Subject: RE: NYM/2022/0249 Land Adj Low Farm Beacon Way Sneaton E11107-36 Client
08.06.22

Please see attached the drawings amended following your comments of the 13th May. These drawings are intended to provide information to address your points; 1, 3, 4, 5, 7, 8, 10 and 11.

CLIENT:	Mr Stainthorpe
PROJECT:	Low Farm Sneaton
Drawing:	Scheme one Proposed Block Plan
DRAWING STATUS:	Preliminary
DRAWN:	C Eynon
CHECKED:	N I Duffield
SCALE @ SIZE:	1:200@ A1
DATE:	15/06/17
DRAWING No:	D11107-03
REV:	I

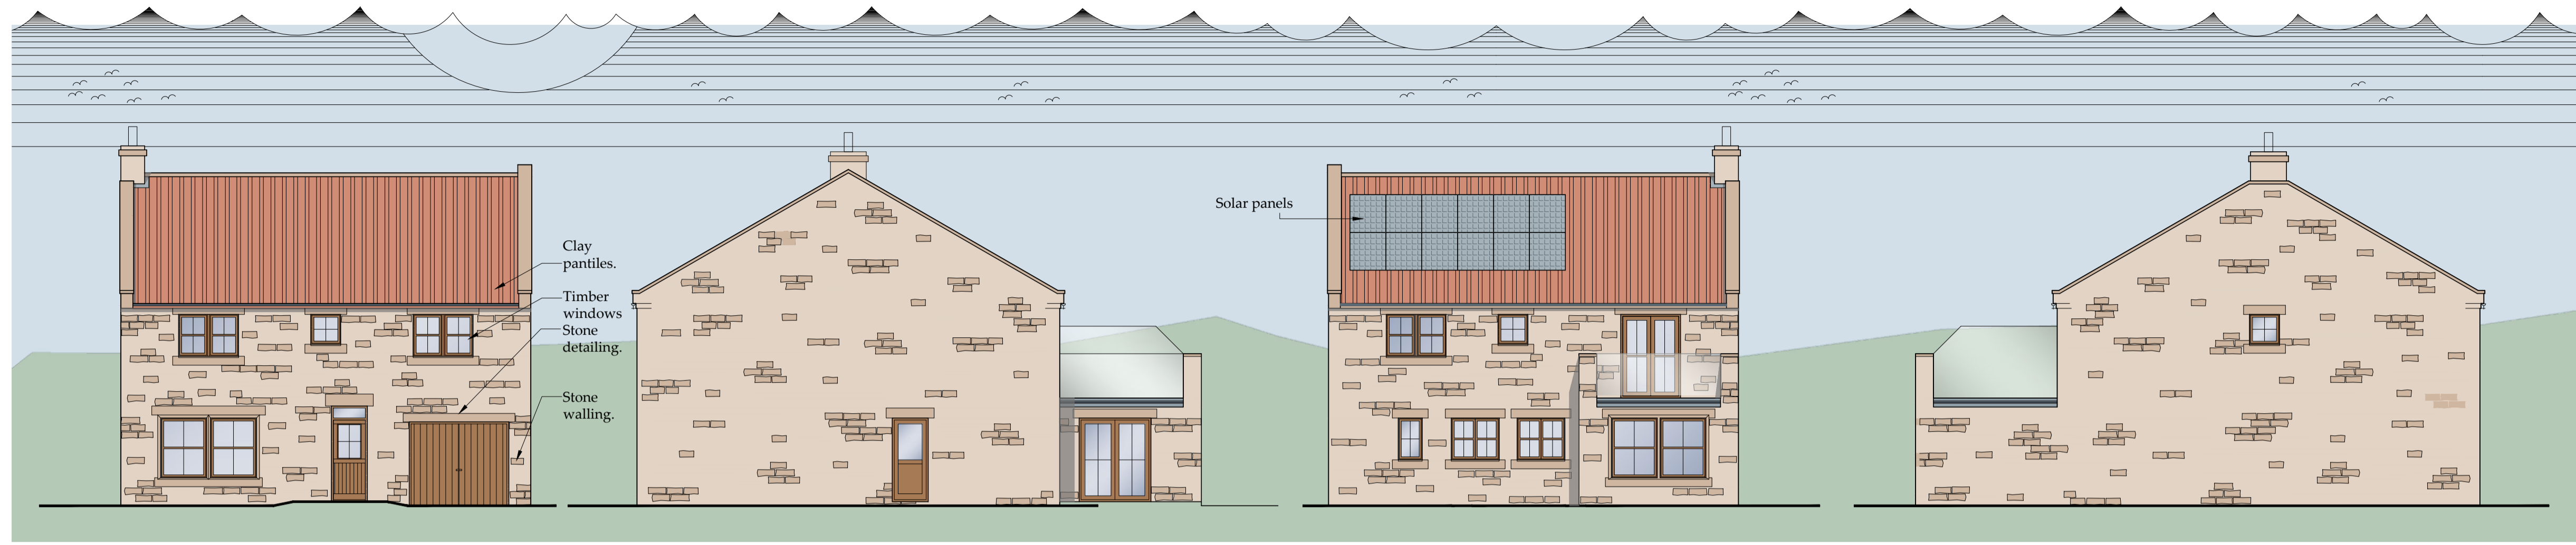
Items 3, 4 and 5, Site Plan; Oak trees to rear boundary, traditional 6 species hedging to rear, side and 3 Party wall lines. Solar panels (PV and thermal), car charging points. Surfacing change to large area in front of 5 and 6. In terms of energy efficiency it means we have Air Source heat pumps are shown to all properties and additional solar panels to all New builds.

Form new openings for access. 4No. openings for 9 properties to ensure retention of the wall as a feature of the street scene.

12No solar panels to each dwelling

Four Oak trees and 6No. native species hedging.

Drawing: **Plot 1 Proposed Floor Plan and Elevation**

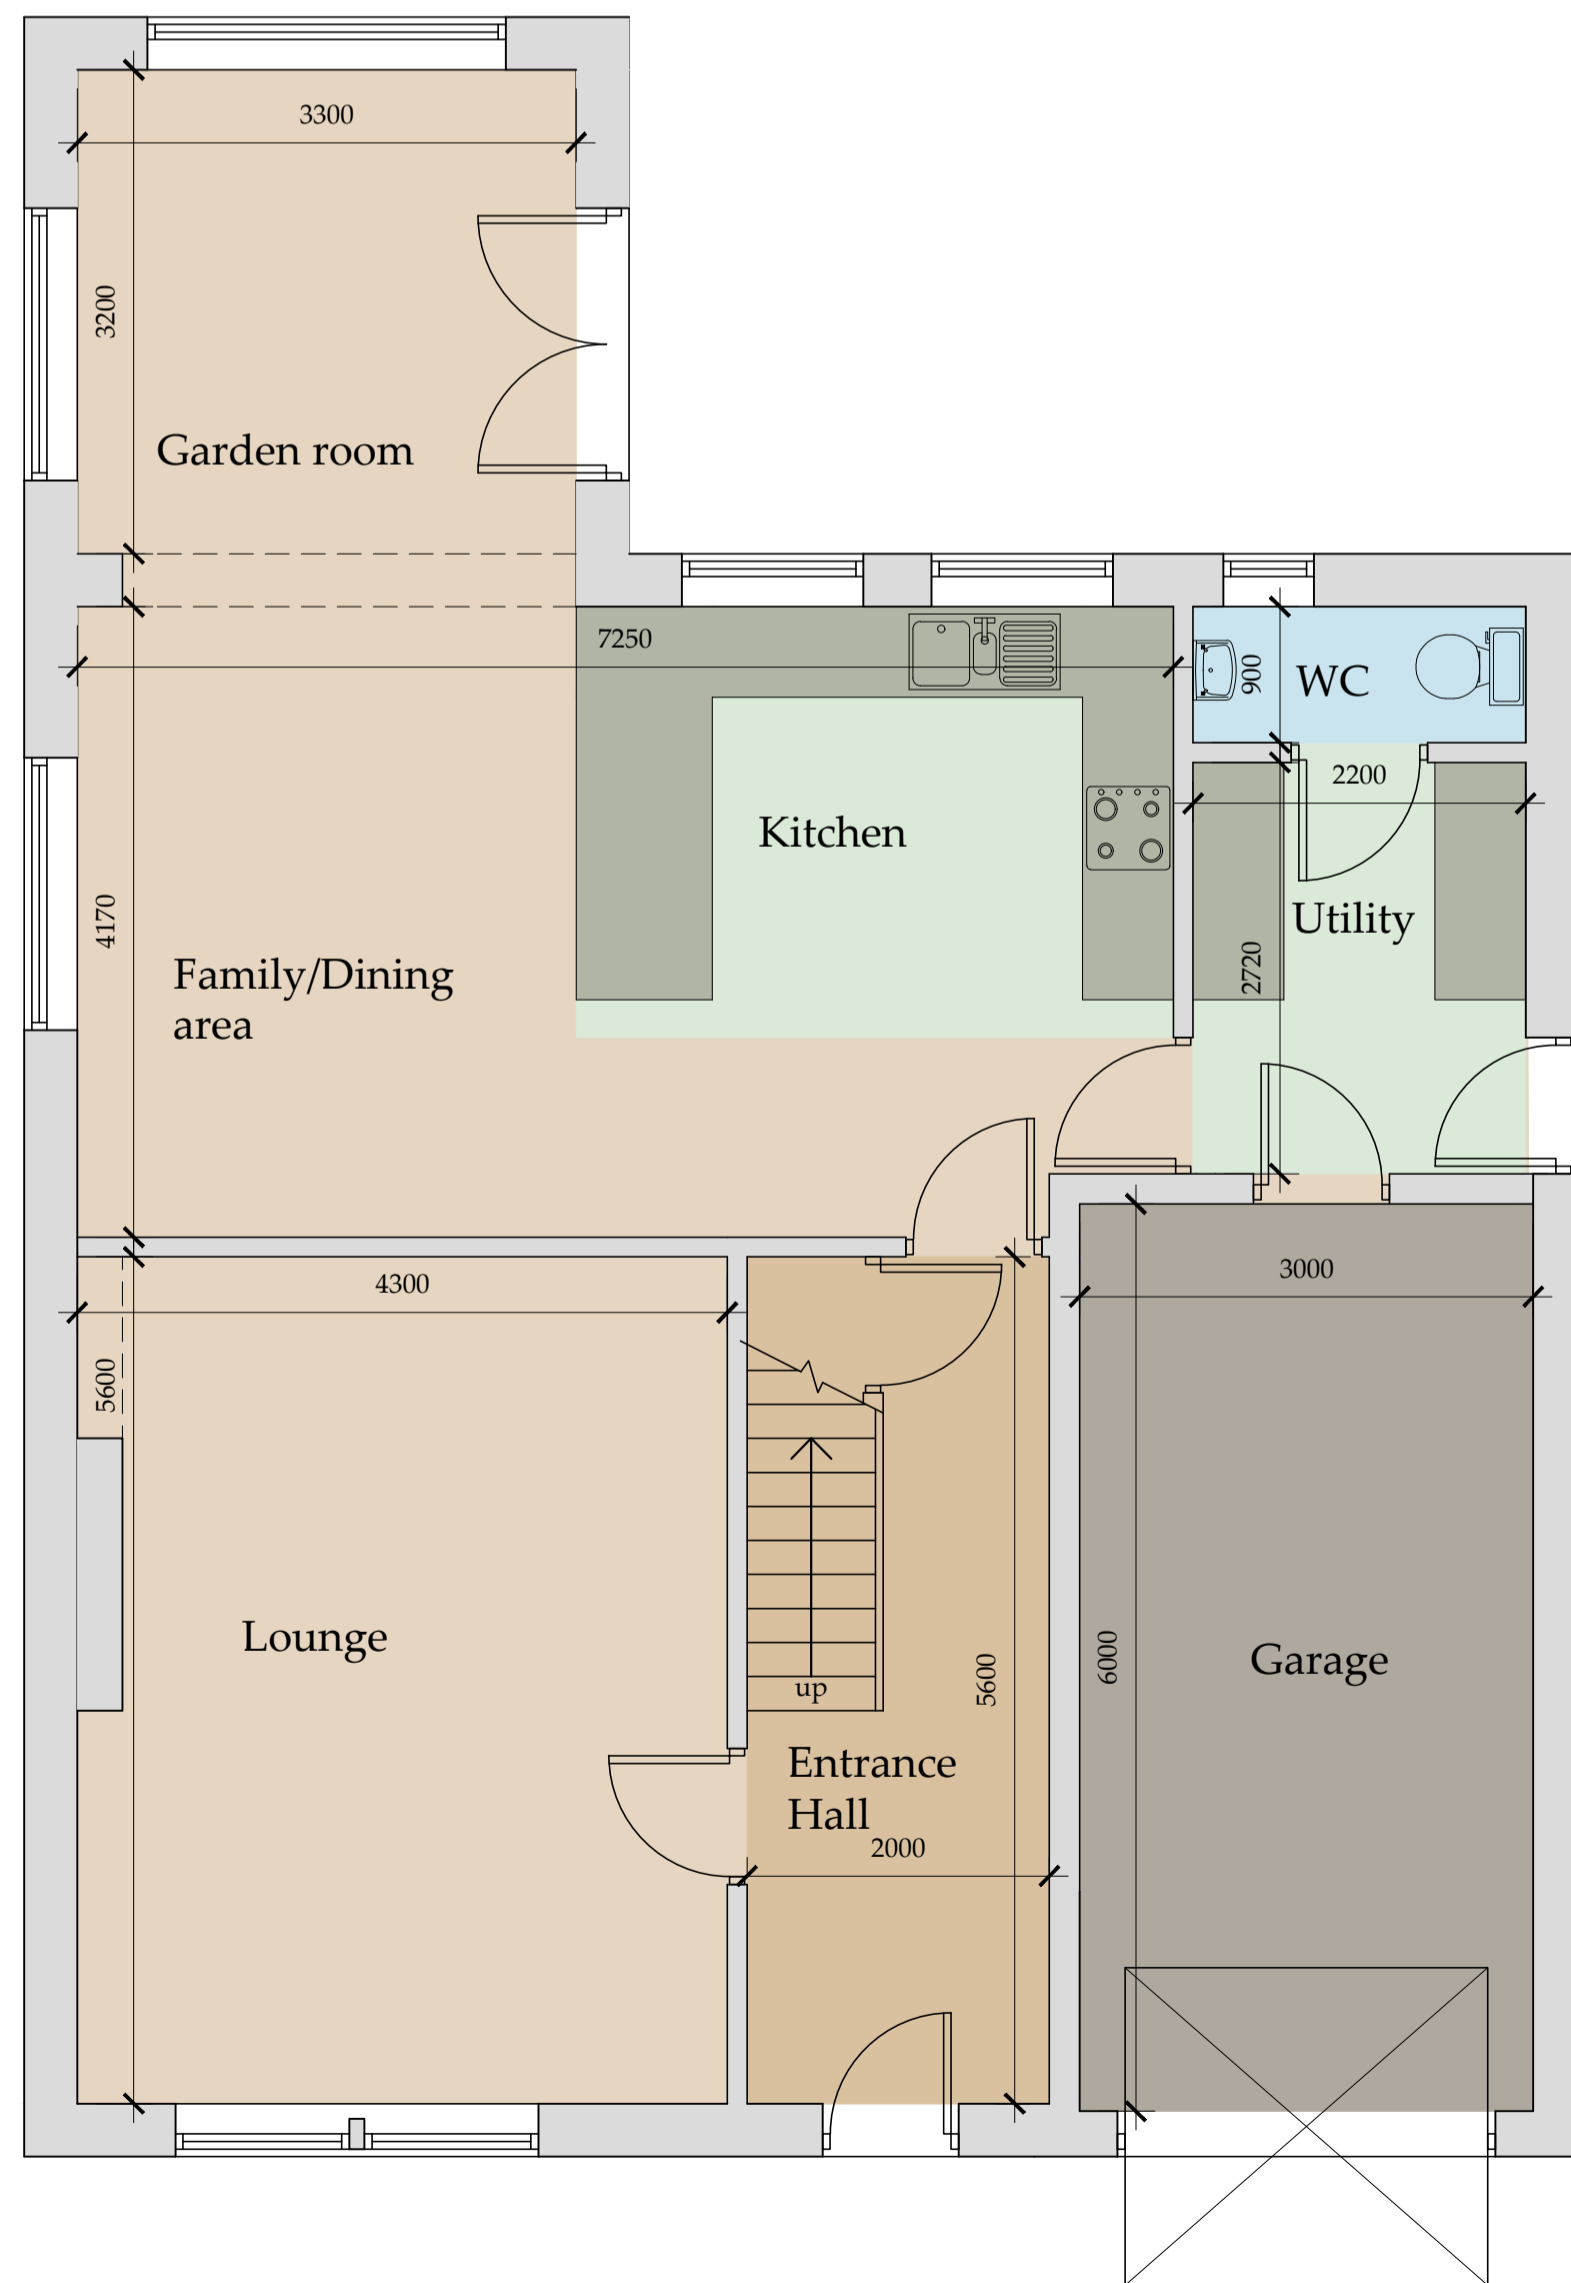
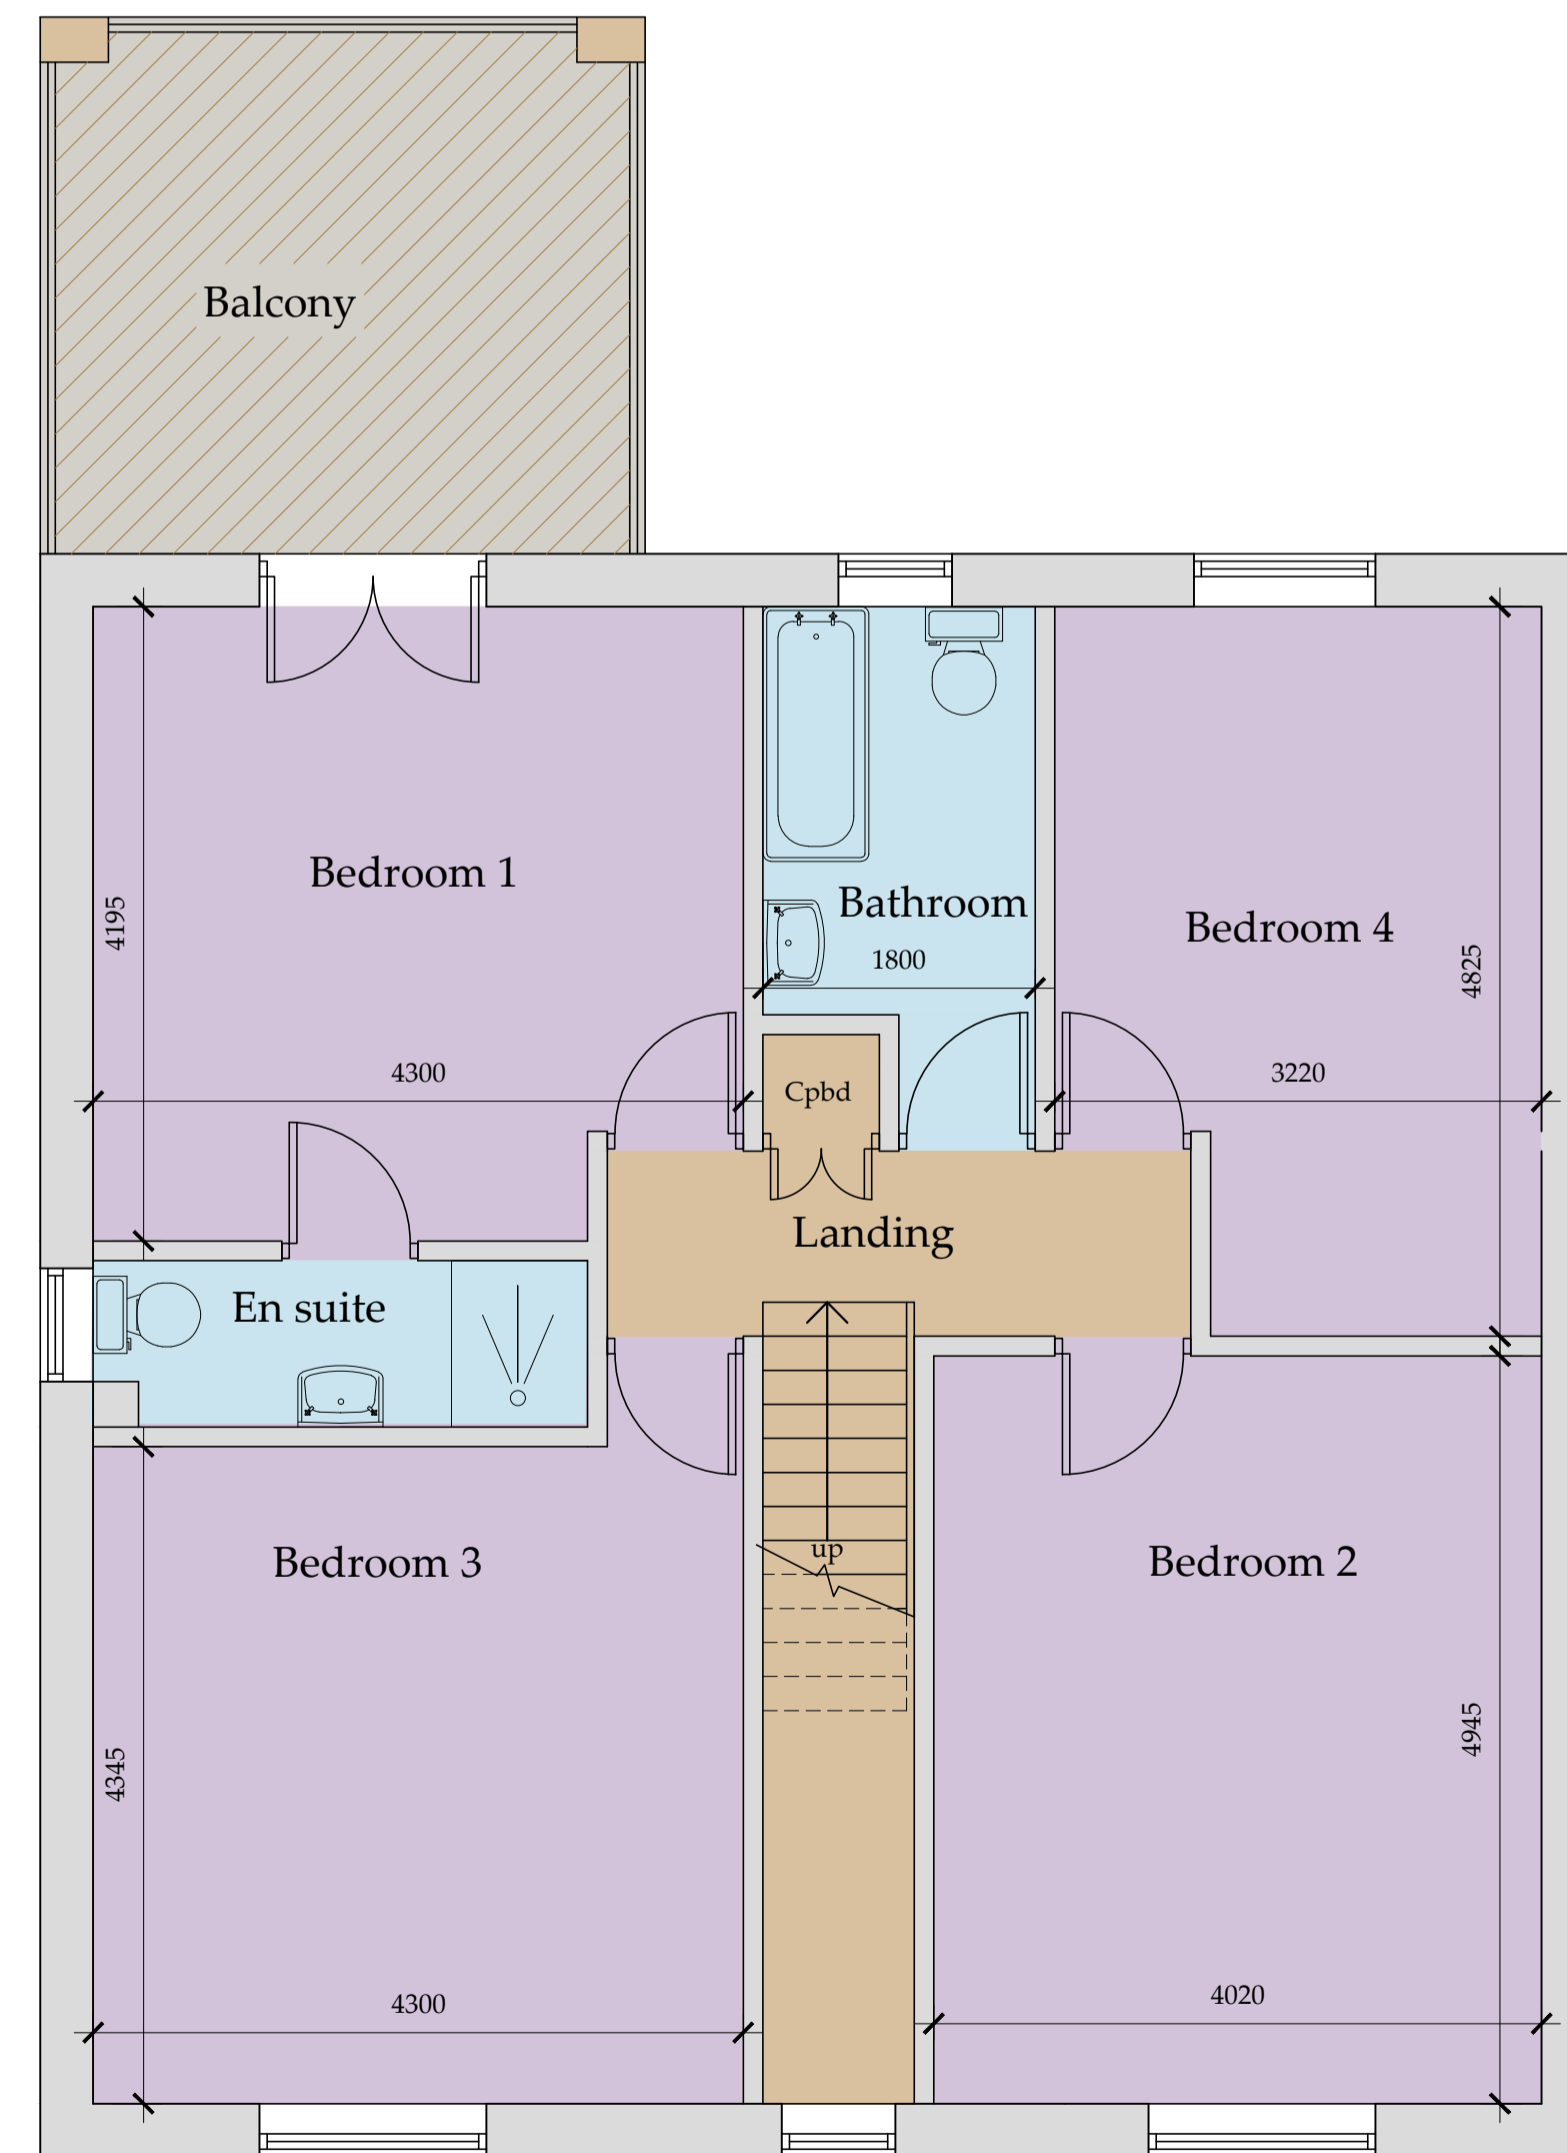
Item 7. Plots 1 and 2; Front elevation extended forward to create single plane façade. We could put a canopy on? Front door sidelight removed. Fanlight added. Minor changes made to 1st Floor layout. They could benefit from some other internal changes but these can be carried out after the planning decision.

Item 7- As previous email .The projecting porch and garages to the detached units have been removed as requested, see drawings.
